**SUBDIVISION,
PLANNED UNIT DEVELOPMENT, &
REZONING STAFF REPORT****Date: December 15, 2016****APPLICANT NAME**

Broad Street Lofts Subdivision

Subdivision Approval to create a single legal lot of record from one legal lot of record and one metes-and-bounds parcel; Planned Unit Development to allow multiple buildings on a single building site along with shared access and parking; and Rezoning from R-1, Single-Family Residential District and R-3, Multiple-Family Residential District to R-3, Multiple-Family Residential District to eliminate split zoning and allow an apartment complex.

SITE PLAN

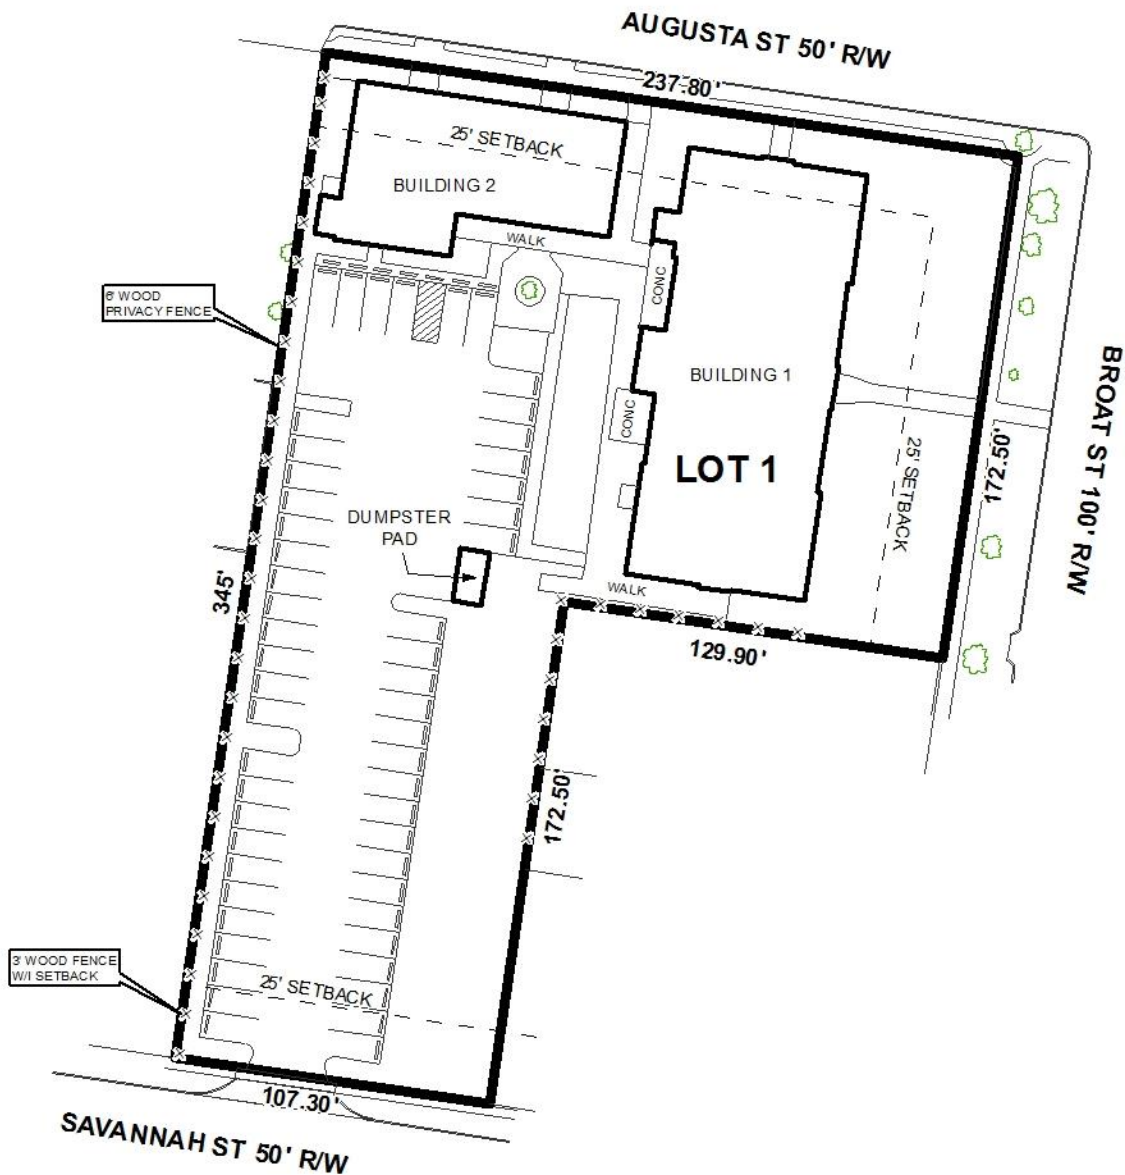
The site plan submitted states that the site will be in full compliance with landscape areas and tree planting requirements. There are several trees existing on the site they wish to use as tree credits, however, it should be noted that all of the trees except one that are illustrated on the site plan are located in the right-of-way and not the actual property. While the existing trees in the right-of-way cannot be used for tree credits, the existing canopies associated with these trees

may make it less likely for any required frontage trees along South Broad Street to thrive, therefore the site plan should be revised to illustrate the canopies associated with the existing trees in the right-of-way so that the number of required frontage trees can be reduced appropriately. Due to the proximity of the existing structures along Augusta Street, there may also be issues with any required frontage trees to have sufficient room to thrive.

The site plan submitted illustrates two existing buildings which are proposed to consist of 28 dwelling units, with 24 one bedroom / one bathroom units, and 4 two bedroom / two bathroom units. The site plan illustrates 53 parking spaces, which exceeds the minimum requirement of 42 parking spaces. It should be noted that the narrative submitted also states that additional street parking will be available along Augusta Street, however none is illustrated on the site plan.

A dumpster is illustrated on the site plan with an enclosure and connection to sanitary sewer. This should be retained on the site plan, if approved.

The site plan submitted illustrates a 6' high wooden privacy fence (reduced to 3' high within the 25' building setback) next to most, but not all, of the adjacent R-1, Single-Family Residential District, and a 3' high hedge or wood fence proposed to screen the proposed parking areas from residences across Savannah Street. The site plan should be revised to illustrate a wooden privacy fence next to all adjacent R-1, Single-Family Residential District properties.

- 1) illustrate the canopies associated with the existing trees in the right-of-way at time of permitting;
- 2) full compliance with Traffic Engineering comments: *(Based on the proposed density for this site, a traffic impact study will not be required. Site is limited to one curb cut to Savannah Street, with size, location and design to be approved by Traffic Engineering and conform to AASHTO standards. Any new on-site parking, including ADA handicap spaces, shall meet the minimum standards as defined in Section 64-6 of the City's Zoning Ordinance. Regarding the parking on a side street, Live Oak Street appears to be approximately 28 feet in width. According to City Code Sec. 61-264 (a), the City Traffic Engineering is authorized to restrict parking upon one side of a street as indicated by such signs when the width of the roadway does not exceed 30 feet. In addition, parking prohibitions can also be enforced without signage within 30 feet of an approach to a stop sign or traffic signal and within 10 feet of a fire hydrant. A signed restriction may be placed by Traffic Engineering if parking violations are excessive, or the fire department deems it necessary.);*

- 4) compliance with Fire comments (*All projects within the City Limits of Mobile shall comply with the requirements of the City of Mobile Fire Code Ordinance. (2012 International Fire Code)*);
- 5) revision of the site plan to illustrate a wooden privacy fence next to **all** adjacent R-1, Single-Family Residential District properties (3' high in 25' minimum building setback, 6' high elsewhere); and
- 9) provision of two (2) revised PUD site plans to the Planning Division prior to the signing of the Final Plat.
